MEMORANDUM

To: Cosmas P. Diamantis, Esq., Director of Community Development
From: Joseph Burgis PP, AICP, Edward Snieckus, PP, LLA, ASLA, and Robyn Welch PP, AICP
Subject: Cherry Hill Planning Board
Devel, LLC – Phase 1 & 2 and Phase 3
Application #17-P-0041 and #18-P-0002
Date: February 16, 2023
BA#: 3858.01

Drawing Name Affordable Unit Distribution Study	Project No. 3858.01	Drawing Date 0207.23	Addendum No. X of X
	Drawing Scale 1" = 40'	Sheet No. X of X	Drawing No. C-1
Project Name Cherry Hill-Devel LLC		2023 COPYRIGHT BA - NOT TO BE REPRODUCED

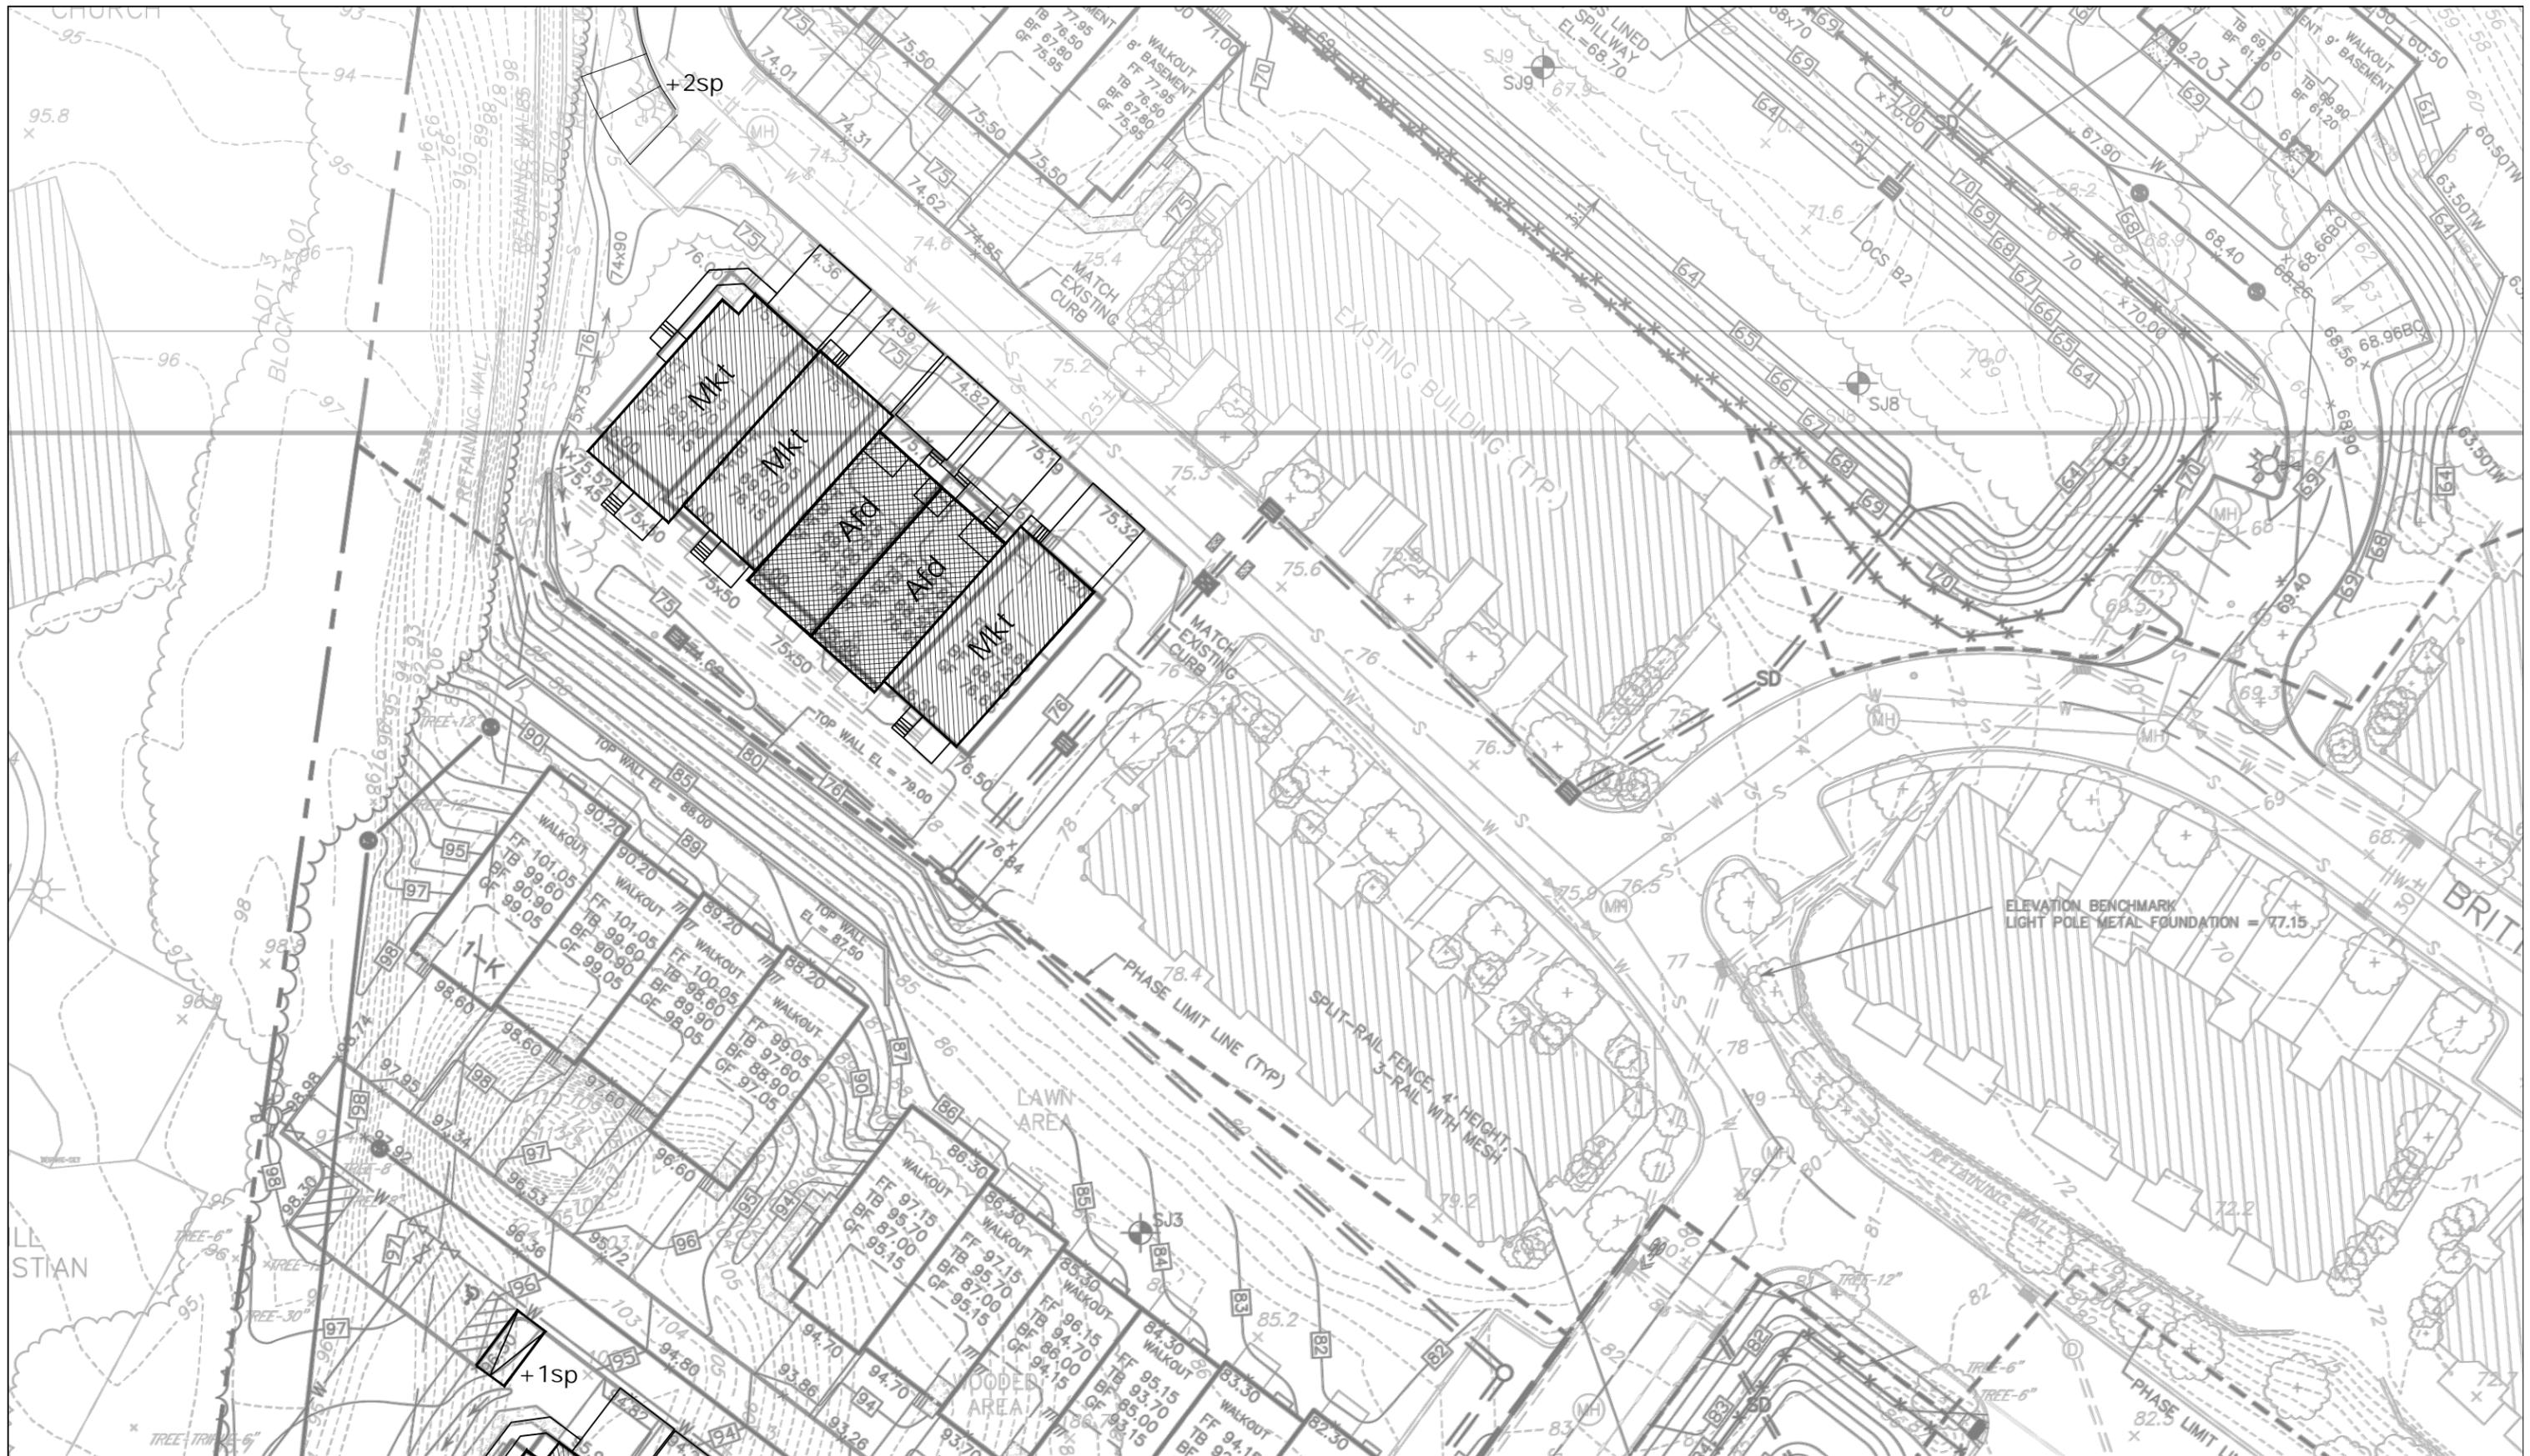
Attached to the end of this report are two conceptual plans prepared by our office which demonstrate how Building 2-C (which the applicant proposes to contain 10 affordable units and no market rate units) could be redesigned for mixed-income units. As shown, we believe that 2 of the affordable units in Building 2-C can be relocated to Building 1-I, that 4 of the affordable units in Building 2-C can be relocated to the 5-unit infill building in the Normandy section of the development, and that the affordable units relocated from Building 2-C can be replaced with 3 market rate units. As detailed in the table below, this redistribution would maintain the same number of market rate and affordable units as are currently being proposed – both in terms of overall numbers in the development and within the respective H.O.A.s.

Building (HOA)	Proposed Distribution			Recommended Distribution		
	Market	Affordable	Total	Market	Affordable	Total
Infill (Normandy)	5 (100%)	0	5	3 (43%)	4 (57%)	7
1-I (Normandy)	7 (100%)	0	7	6 (75%)	2 (25%)	8
2-C (Normandy)	0	10 (100%)	10	3 (43%)	4 (57%)	7
Total	12	10	22	12	10	22

Not only does this redistribution satisfy the integration requirements set forth in the Township’s Zoning Ordinance and the COAH regulations, but it also takes into account the site’s topography and grading, the necessary parking supply and access thereto, and first floor ADA accessibility requirements, all of which were identified as impediments to integration by the applicant. Further, it is noted that while the attached conceptual plans show the proposed affordable units as being located within the interior of the mixed-income buildings, same could easily be redesigned as end cap units if construction requirements warrant.

As such, it is our opinion that it is both possible and feasible to integrate the development’s affordable units to a greater extent than is currently being proposed. The applicant should either incorporate these changes into their plans, or be prepared to demonstrate for the Board why this statutory requirement cannot be met.
